AGENDA
DEVELOPMENT AND PLANNING COUNCIL SUBCOMMITTEE MEETING

Monday, May 17, 2021 @ 8:00 a.m.

Discussion Item #1: Westowne Center PUD

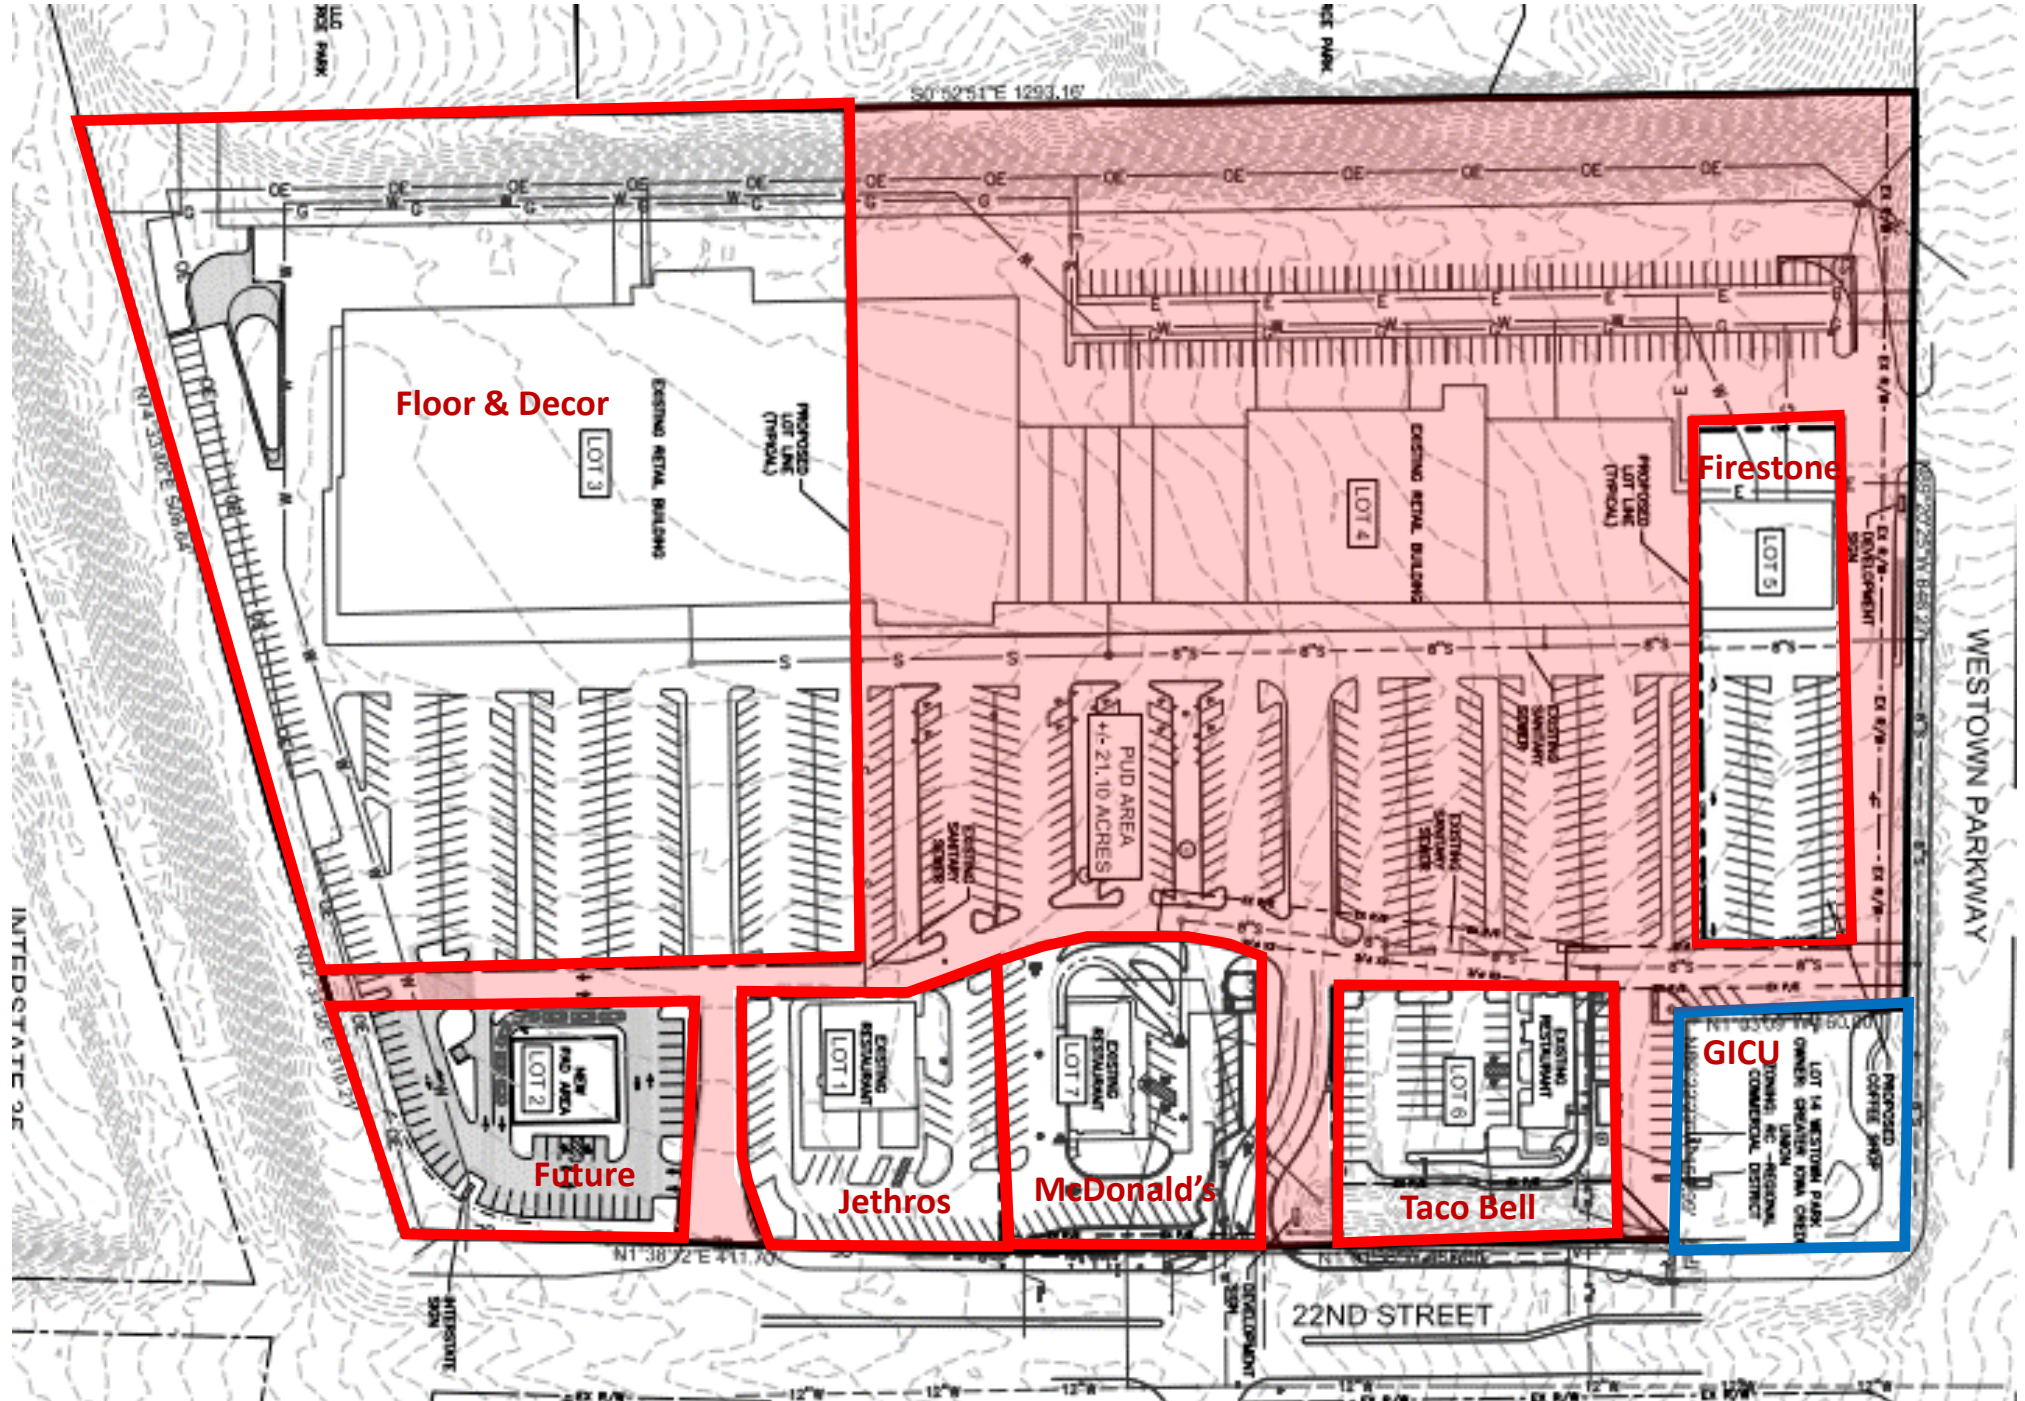
Allow lots less than code as long as executed Ingress/Egress Easements and Cross Parking: minimum lot size as necessary to accommodate code for open space, drive aisle widths, parking stall dimension, and landscaping for visual mitigation

<i>Current Site Condition</i>	20% (187,268sf)
<i>City Code Requirement</i>	25% (229,829sf) Deficient: 42,561 sf
<i>Previous P&Z/CC action (if any)</i>	1991 Revised Site Plan: COA to install 2.5' berm along 22nd St & replace rock in islands with sod to increase 'green' 1993 Site Plan for Hooter's: COA to landscape along 22nd St to increase 'green' & repair west side drives
<i>Applicant's Request</i>	existing lease agreements prevent changing new lot will be developed compliant to 25% OS
<i>Staff's Recommendation</i>	Addition of landscape islands and pods per code will increase OS - provide plan illustrating locations consistent with code No immediate action - implementation upon/aligned with expiration of lease agreements New lot provide per code at time of development

<i>Current Site Condition</i>	approx 45' (Westtown); 80' (22nd Street); approx 90' (west); & 60' (south)
<i>City Code Requirement</i>	100' front (Westtown & 22nd St); 50' (west & south) Deficient Westtown setback
<i>Previous P&Z/CC action (if any)</i>	Variance granted allowing 80' setback for Taco Bell
<i>Applicant's Request</i>	25' along Westtown; 80' along 22nd St - new building will be no closer than others; 10' along side (south?); and 25' along rear (west?)
<i>Staff's Recommendation</i>	agree with 80' along 22nd St; okay with reduced on Westtown - confirm setback available from existing buildings upon dedication of additional ROW and set setback distance accordingly; maintain 50' code side and rear (south & west) - site complies today: nothing proposed to suggest need less 0' internal lot lines unless Bldg or Fire requires different

<i>Current Site Condition</i>	20' ROW dedication along Westtown will result in private improvements on City property (drive aisle and proposed development sign)
<i>Applicant's Request</i>	Okay with dedicating but request allowance of private improvements (existing & proposed) be allowed
<i>Staff's Recommendation</i>	Allow with execution of hold harmless and removal/repair agreement

<i>Current Site Condition</i>	<p>approx 10' from 22nd Street & Westown (ROW dedication along Westown will result in zero setback)</p> <p>no effective landscaping or berming along 22nds St or Westown</p>
<i>City Code Requirement</i>	<p>15' from boundaries; 5' internal unless part of a shared parking concept screened to minimum height of 3' (vegetation + berming)</p> <p>Deficient setback along Westown (will get worse) & no screening of parking</p>
<i>Previous P&Z/CC action (if any)</i>	<p>1993 Revised site plan - variance granted allowing 10' setback along 22nd Street with installation of buffer & 2.5' berm</p>
<i>Applicant's Request</i>	<p>accept current setback - new lot will not be any closer</p>
<i>Staff's Recommendation</i>	<p>agree with 10' along 22nd St -- new building no closer; -- require installation of landscape vegetation (berming if possible) -- timing??</p> <p>0' setback along Westown due to dedication of additional ROW -- allow plantings in ROW at edge of current drive aisle</p> <p>maintain 15' code side and rear (south & west) - site complies today: nothing proposed to suggest need less</p> <p>0' internal between lots</p>

<i>Current Site Condition</i>	950 stalls ** indicated some may not meet code minimum for length dimensions -- 118 stalls are behind the building (NW corner) Original site plan required 894 and provided 1051 in 1991 -- Shared Parking Agreement executed
<i>City Code Requirement</i>	For a Planned Commercial Center = 881 On a per use basis w/ existing tenants + future lot = 830
<i>Previous P&Z/CC action (if any)</i>	none known
<i>Applicant's Request</i>	existing lease agreements prevent changing
<i>Staff's Recommendation</i>	require lesser of two as long as valid shared parking agreement across the center exist // new drive-thru businesses require queuing per code

<i>Current Site Condition</i>	Stall width generally is compliant; stall depths less than code in areas -- mainly angled parking drive aisle widths are generally compliant -- one known issue with bi-directional angled parking on less than 24' aisle
<i>City Code Requirement</i>	9' stall width: 17' or 19' length and 24' drive aisle for 90° parking; 24' length for 60° and 18' one-way drive aisle or 24' if two-way drive aisle Deficient stall length and some drive aisle widths
<i>Previous P&Z/CC action (if any)</i>	none known
<i>Applicant's Request</i>	existing lease agreements prevent changing
<i>Staff's Recommendation</i>	Work with Emergency Response agencies to identify areas in which surface repairs are urgent No immediate action -- however, ** Restrip areas as possible compliant with code at such time that parking lot maintenance (overlays) is done, including fix striping of known bi-directional lane when first overlay and striping of another area is done ** Reconstruct areas compliant when full tear out to sub-base is done

<i>Current Site Condition</i>	some linear islands; very few terminal islands; no tree pods
<i>City Code Requirement</i>	terminal islands at end of each parking row and every 18 stalls (min 9' width x length of stall) tree pods between and at least every 9 stalls (min 6') linear islands every 6 rows of parking (min 10' width) 1 tree per pod and for each 9' x 17' island Site generally deficient
<i>Previous P&Z/CC action (if any)</i>	none known
<i>Applicant's Request</i>	existing lease agreements prevent changing
<i>Staff's Recommendation</i>	Provide planting plan for current linear islands and existing pods - install number of trees consistent with code requirements Other areas no immediate action -- however, ** When full tear out to sub-base is done for maintenance - change striped islands to raised islands and install required trees ** Upon expiration of current lease agreements and when full tear out to sub-base is done - implement required terminal islands (no islands within a row or pods requirement) and install required trees

<i>Current Site Condition</i>	2011 Development Agreement established four phase approach to storm water to bring center into compliance
<i>Applicant's Request</i>	<p>Full Compliance of the existing development agreement is not feasible. Willing to work with the City to accommodate the regional storm water management facility.</p> <p>At this time we request a pause in the requirements of the development agreement as it pertains to implementing the storm water management facilities that would discharge to Westown Parkway. Once the design of the City's regional storm water management facility can be completed, we are willing work with the city by providing space to accommodate facility as long as costs of construction are on the City, and the applicant is not penalized on site impacts such as parking. The provided space would act as complying with City's storm water requirements.</p> <p>Please note, a tenant protected drive extends through the general area of the regional detention location and special accommodations may be needed with those tenants.</p>

<i>Current Site Condition</i>	Private sanitary sewer
<i>City Code Requirement</i>	Public sewer to all lots
<i>Applicant's Request</i>	Allow sewer to remain private until such time that repairs are needed
<i>Staff's Recommendation</i>

<i>Staff's Recommendation</i>	Need to know of any impacts to parking in order to make accommodations in requirements stated in PUD ordinance

Signage

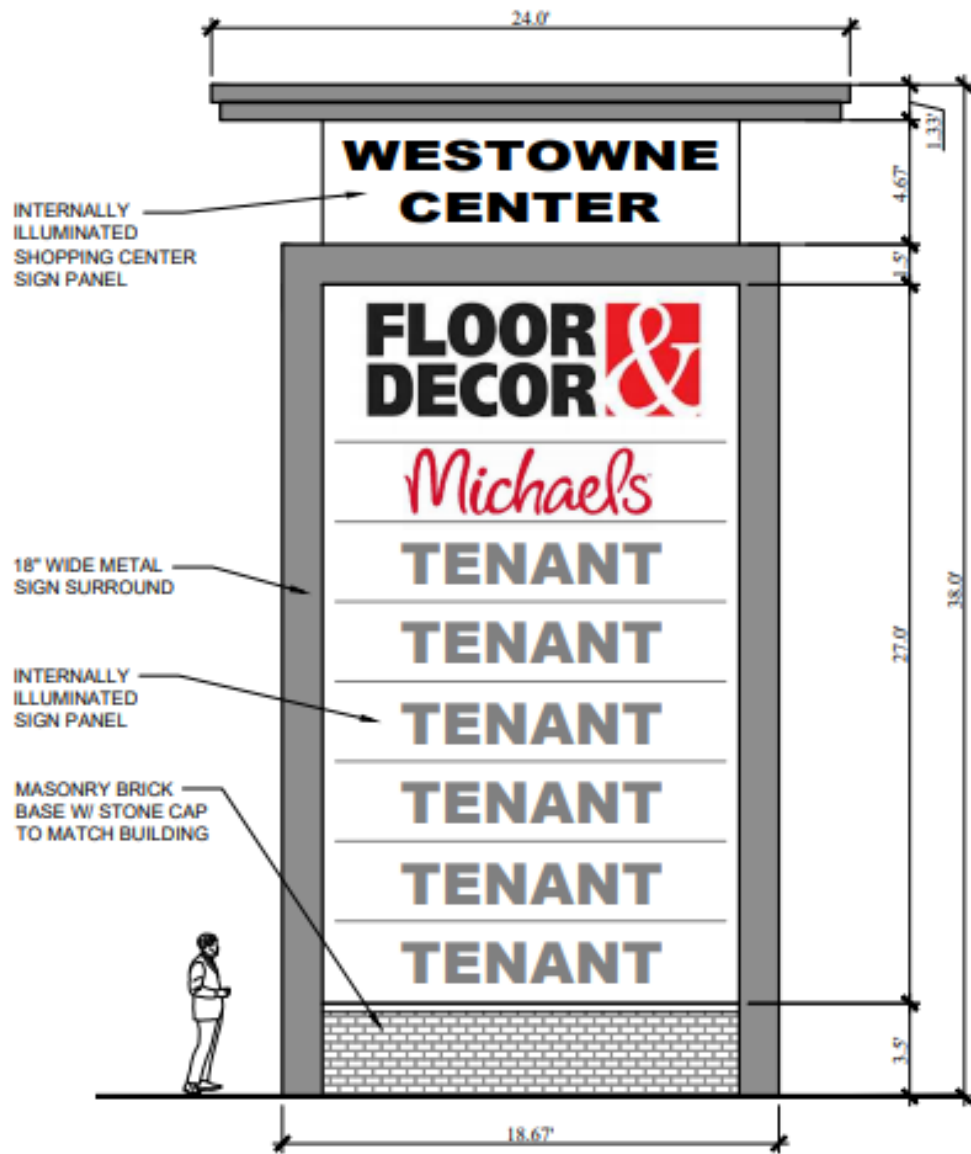
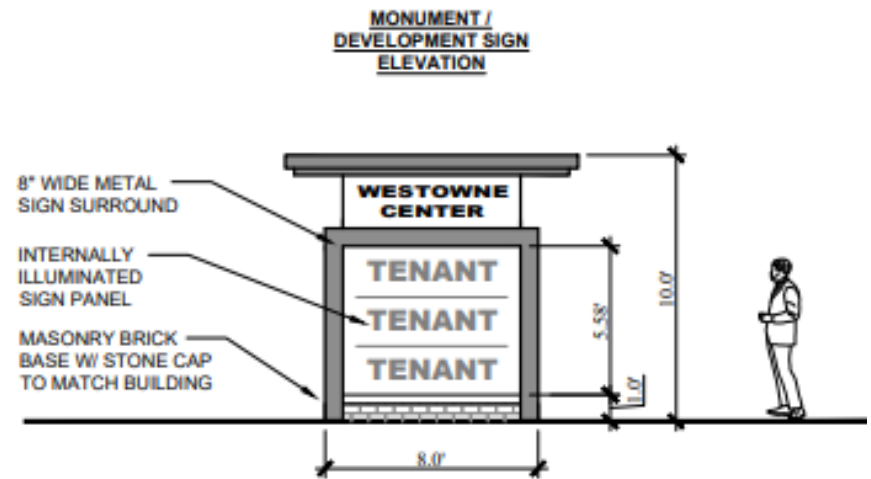
SIGN PROPOSED (PUD)
496 S.F. PER FACE
38'-0" HEIGHT

SIGN PROPOSED (PUD)
50.5 S.F. PER FACE
10'-0" HEIGHT

<p><i>Current Site Condition</i></p>	<p>Each free-standing building along 22nd Street have ground monument signs; tenants in the main building utilize wall signage @ 1.5sf/lineal foot of tenant space</p>
<p><i>City Code Requirement</i></p>	<p>1sf wall signage per lineal foot due to front parcels Interstate sign requires 300' of frontage & limited to tenants on same parcel as sign // max 30' in height x 12' width // 200sf of copy area (multi-tenant) // 3-dimensional and opaque background // 10' setback from interstate ROW and 100' from adjoining lot line Ground Monument Signs: 150' lot frontage & limited to tenants on same parcel as sign // 150' separation from another sign // max 5' height x 7' width w/ 35sf copy area @ 10' setback OR max 7' height x 9' width w/ 64sf copy area @ 20' setback // 3-dimensional lettering & opaque background</p>
<p><i>Applicant's Request</i></p>	<p>Interstate: 27' tall x <18' wide = approx 502sf for tenant identification area + 5' x 15' = 75sf for center identification - overall 38' tall x 24' at widest ('cap') tenant identifcaiton full height of sign Two Development Signs: 6' tall x 8' wide = 48sf tenant identification area + 4' x 6' =24sf for center indentification - overall 10' tall by 10' internally illuminated panels</p>

<p><i>Non-compliant aspects to code of Applicant's Request:</i></p>	<p>Interstate sign exceeds allowed for height, width & copy area // with proposed subdividing into lots - doesn't meet minimum frontage for proposed location & proposes off-premise tenant identification Development signs: has been allowed in developments in lieu of individual ground monument signs - as proposed would place 6 signs along 22nd Street: proposed 22nd Street sign doesn't meet minimum lot frontage or minimum separation requirements (from Taco Bell) // Sign proposed for Westown potentially within city ROW</p>
<p><i>Staff's Recommendation</i></p>	<p>Allow one interstate sign to be located off of proposed lot 2; allow tenant identification of any business in main center building (not tenants on outparcels along 22nd St) under same ownership entity (CCOP provisions) // require size consistent with code Westown Pkwy: Allow ground monument sign in city ROW with hold harmless & removal/repair agreement // allow identification of tenants within the center that don't otherwise have own ground monument sign 22nd St: No additional ground sign except if proposed lot 2 meets minimum frontage requirements & separation requirements from sign on Jethro's lot // size per code based on setback provided;</p>
